Subject: Duke Energy Carolinas, LLC  
Oconee Nuclear Station (ONS), Units 1, 2, and 3  
Docket Numbers 50-269, 50-270, and 50-287  
License Amendment Request to Update Pressure-Temperature Limit Curves  
License Amendment Request (LAR) No. 2012-10

Subject: License Amendment Request to Update Pressure-Temperature Limit Curves  
License Amendment Request (LAR) No. 2012-10

**ATTACHMENT 1**  
**TECHNICAL SPECIFICATION**  
**MARK UPS**

Figure 3.4.3-1 (page 1 of 1)  
RCS Normal Operational Heatup Limitations  
Applicable for the First 33 EFY - Oconee Nuclear Station Unit 1

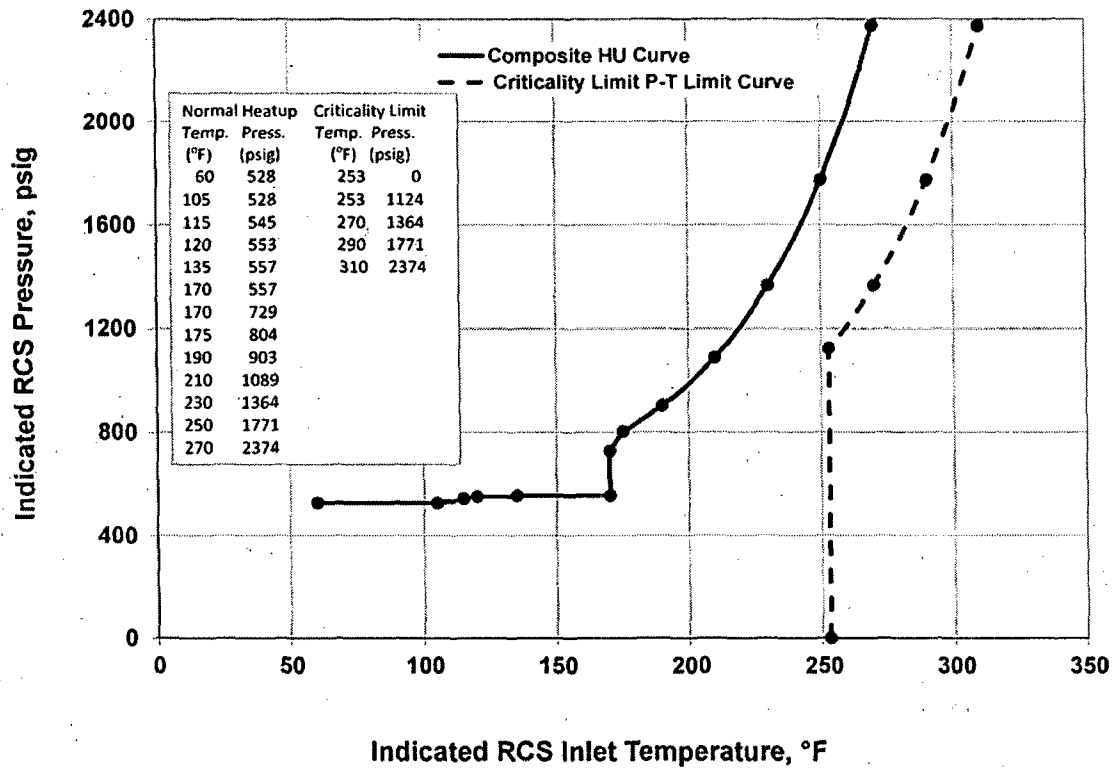
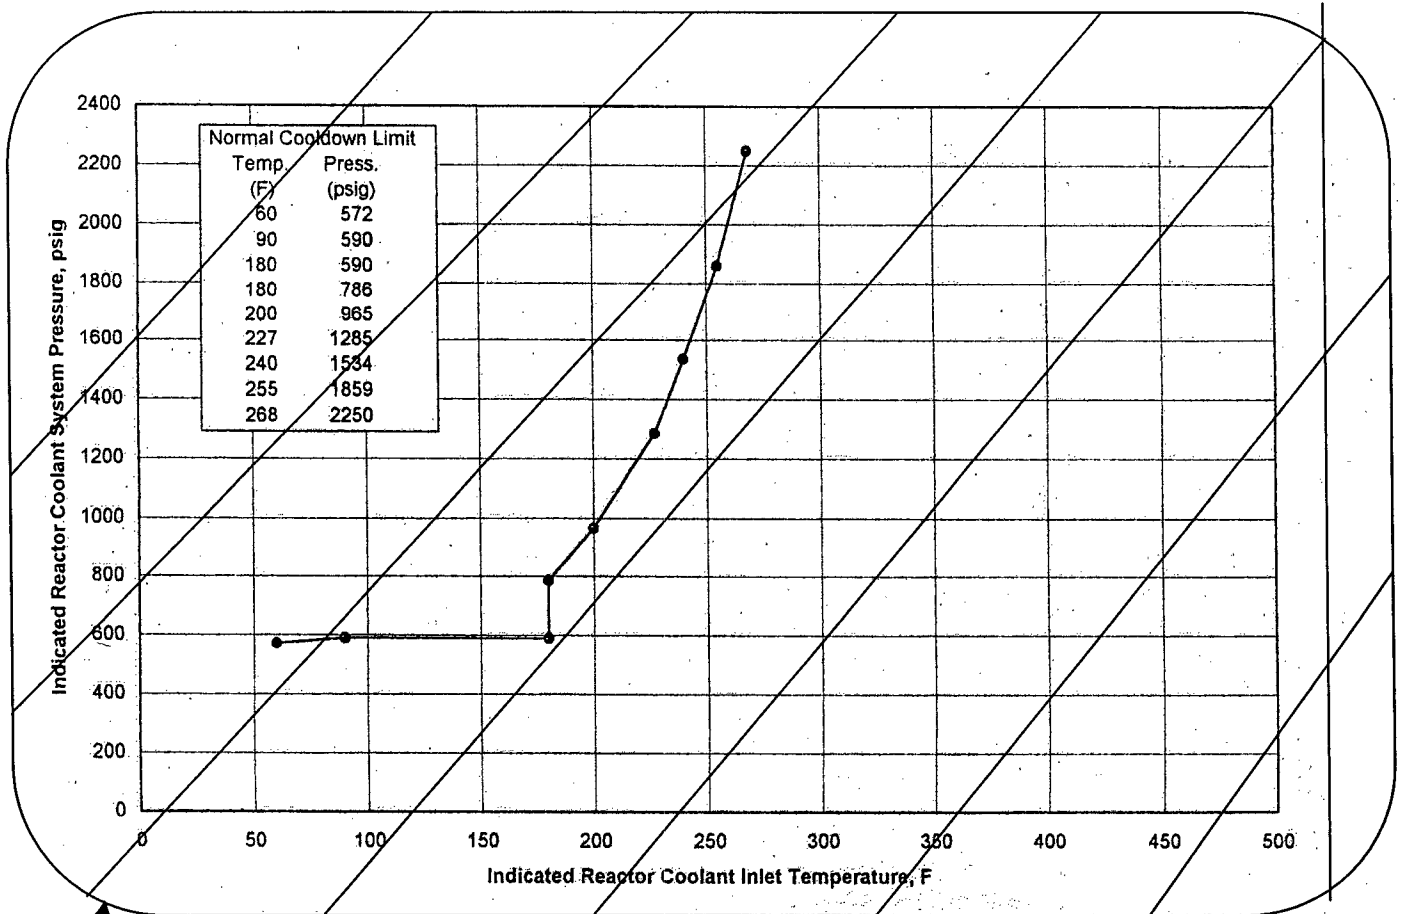
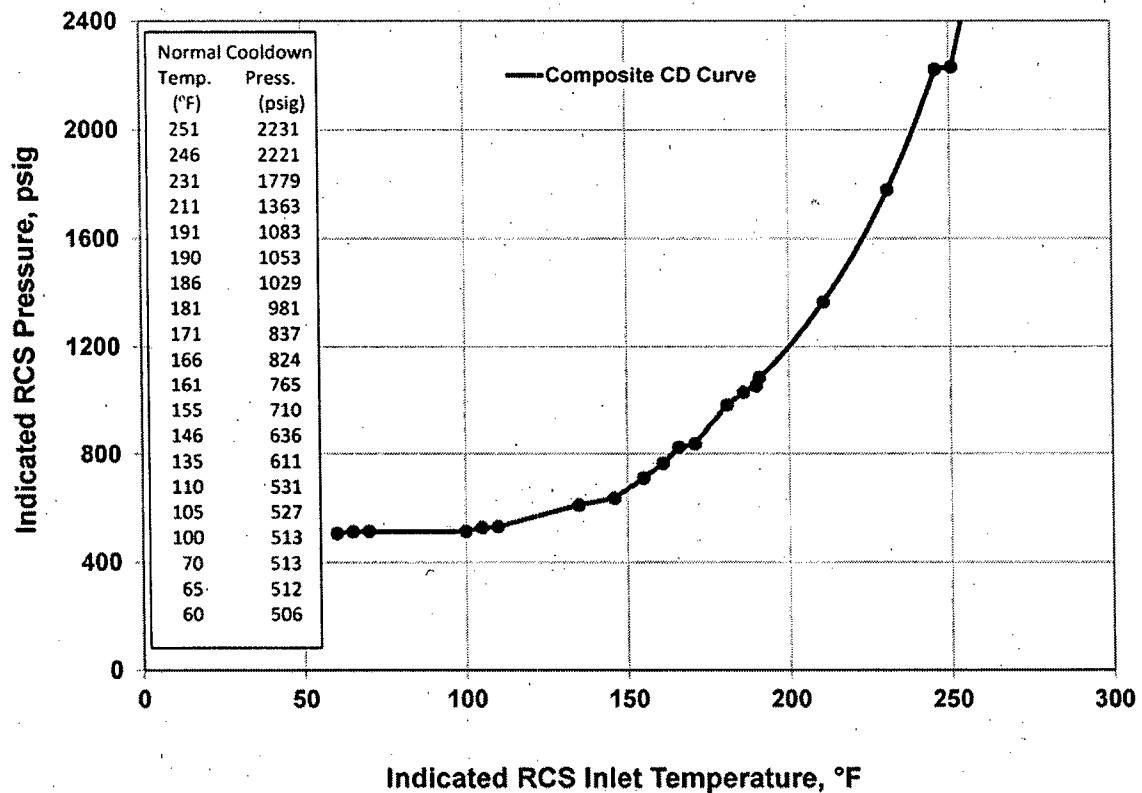
TS Limiting Condition for Operation (LCO) 3.4.3 currently provides the P-T limits for RCS Normal Operational Heatup Limitations, RCS Normal Operational Cooldown Limitations, and RCS Leak and Hydrostatic Test Heatup and Cooldown Limitations applicable to the first 33 EFPY in Figures 3.4.3-1, 3.4.3-2 & 3.4.3-3 respectively for ONS-1, in Figures 3.4.3-4, 3.4.3-5, & 3.4.3-6 respectively for ONS-2, and in Figures 3.4.3-7, 3.4.3-8, & 3.4.3-9 respectively for ONS-3. The proposed change would replace the existing P-T limits for 33 EFPY with P-T limits for 54 EFPY. Also, changes to the operational requirements for unit heatup and cooldown in TS Tables 3.4.3-1 and 3.4.3-2 are proposed. These changes are supported by the new 54 EFPY P-T limits. The proposed changes are depicted in the TS markup and retype provided in Attachments 1 and 2.

INSERT A

Figure 3.4.3-1 (page 1 of 1)  
RCS Normal Operational Heatup Limitations  
Applicable for the First 54 EFY - Oconee Nuclear Station Unit 1

Figure 3.4.3-2 (page 1 of 1)  
RCS Normal Operational Cooldown Limitations  
Applicable for the First 33 EFY - Oconee Nuclear Station Unit 1

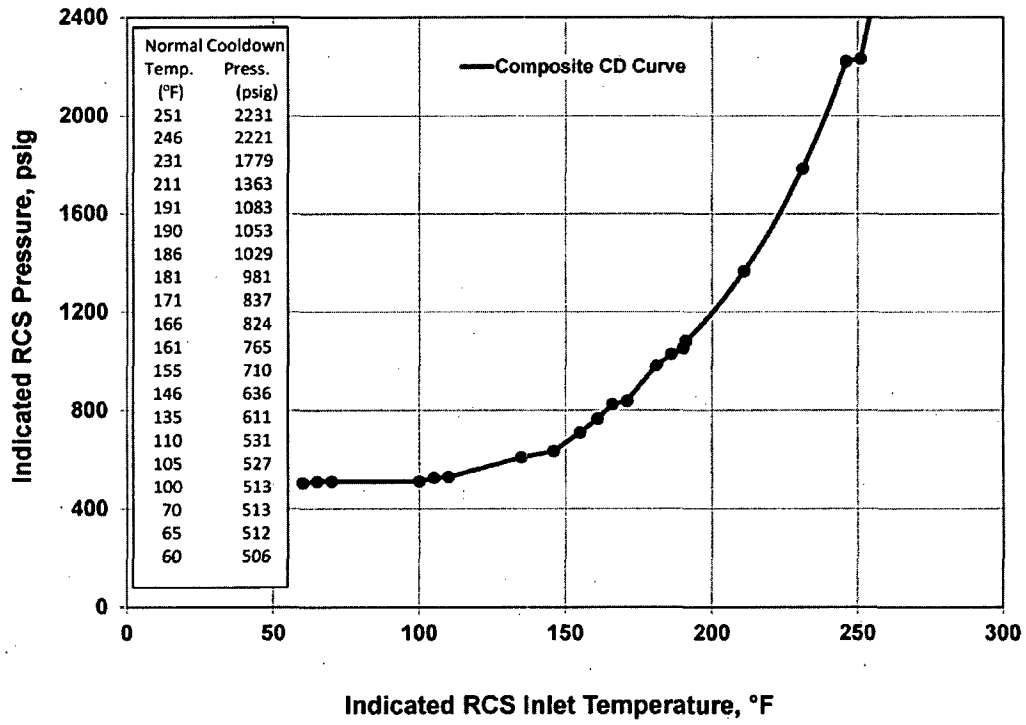
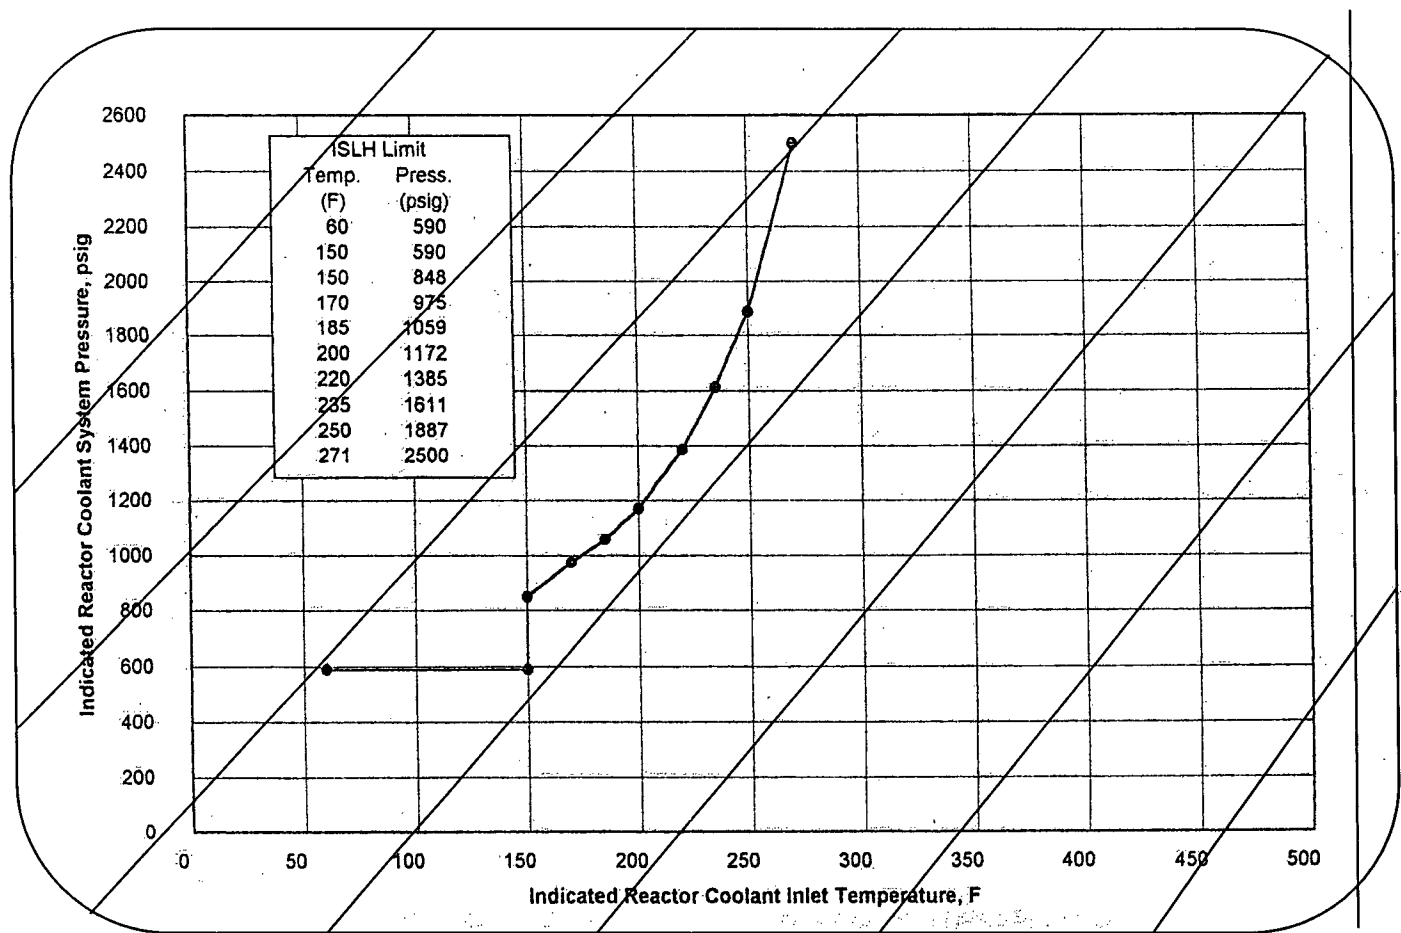
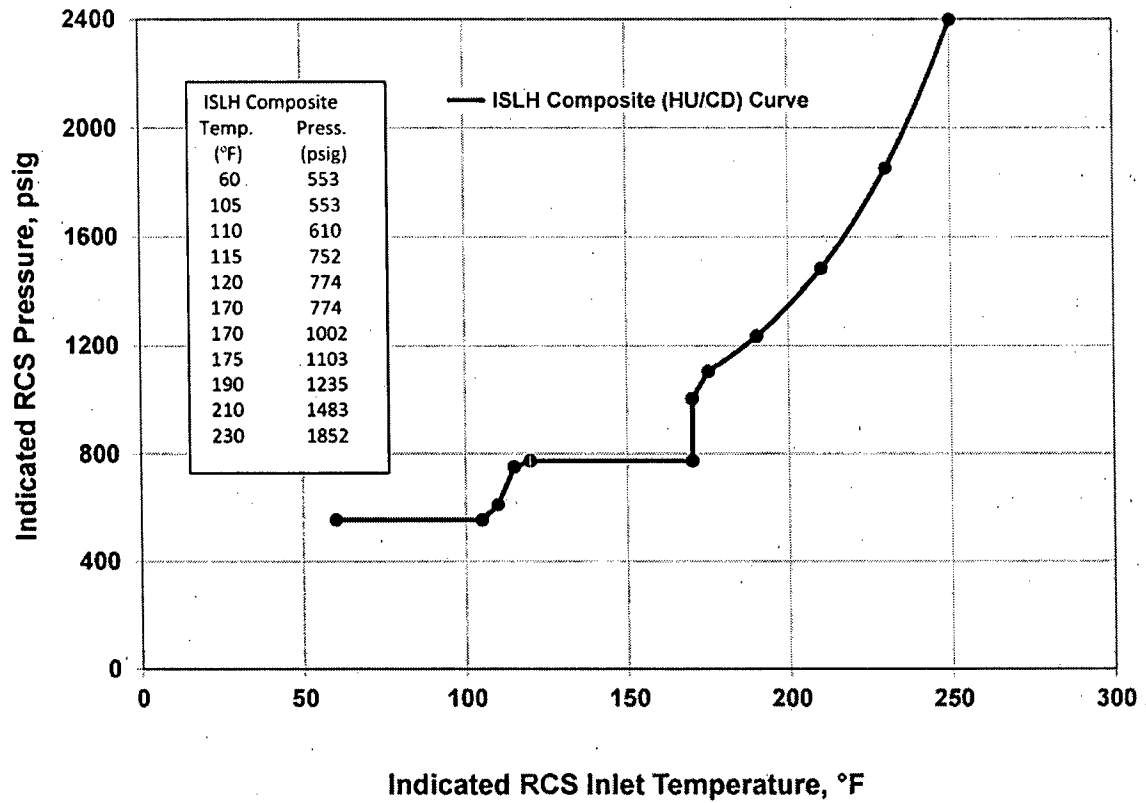
INSERT B

Figure 3.4.3-2 (page 1 of 1)  
RCS Normal Operational Cooldown Limitations  
Applicable for the First 54 EFPY - Oconee Nuclear Station Unit 1

Figure 3.4.3-3 (page 1 of 1)  
RCS Leak and Hydrostatic Test Heatup and Cooldown Limitations  
Applicable for the First 33 EFPY - Oconee Nuclear Station Unit 1

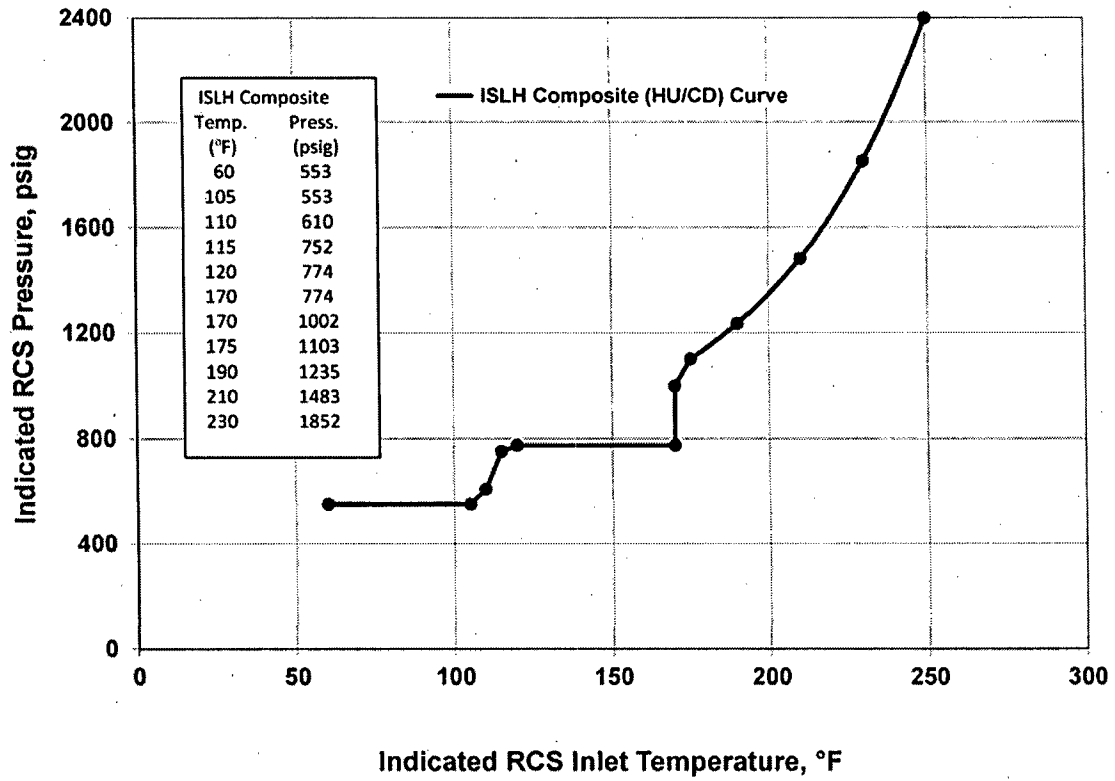
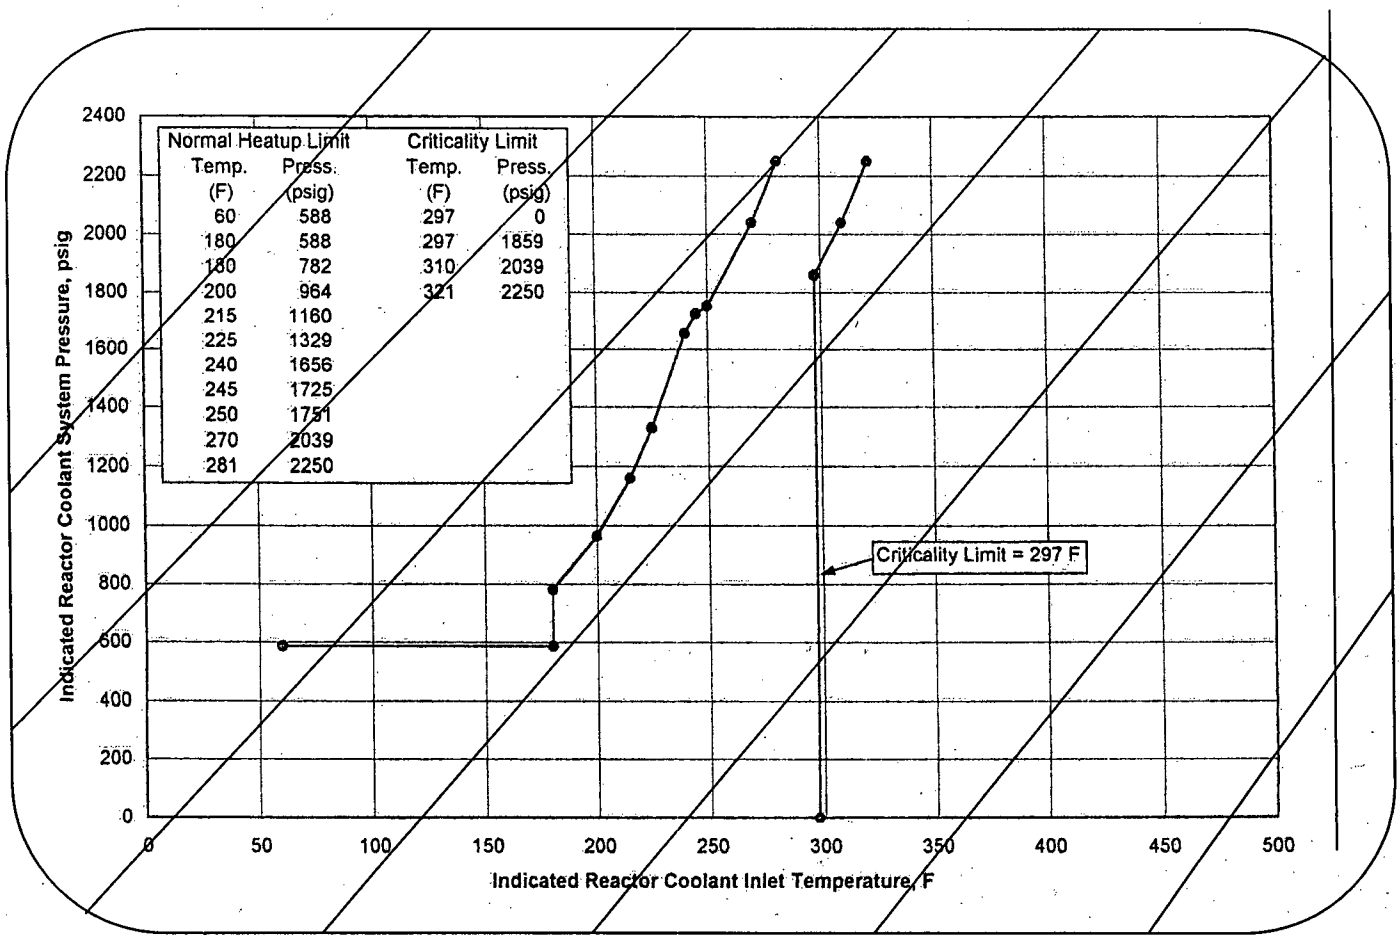
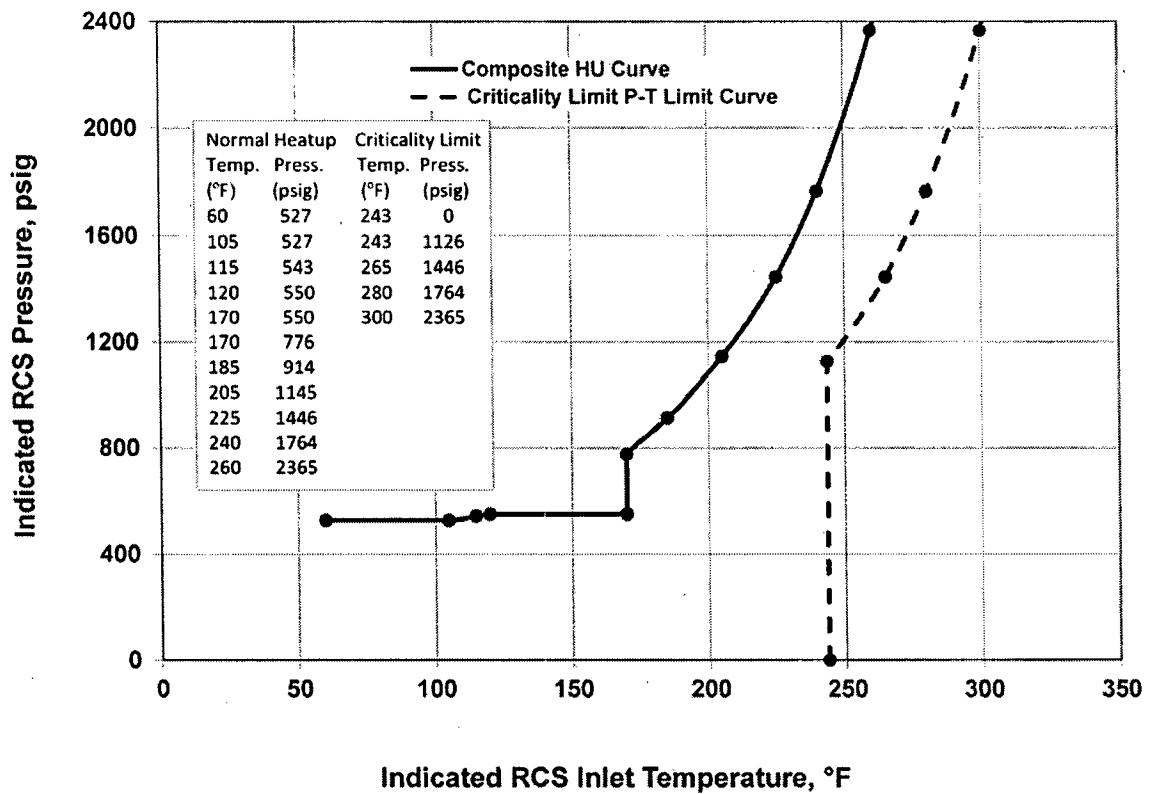
INSERT C

Figure 3.4.3-3 (page 1 of 1)  
RCS Leak and Hydrostatic Test Heatup and Cooldown Limitations  
Applicable for the First 54 EFPY - Oconee Nuclear Station Unit 1
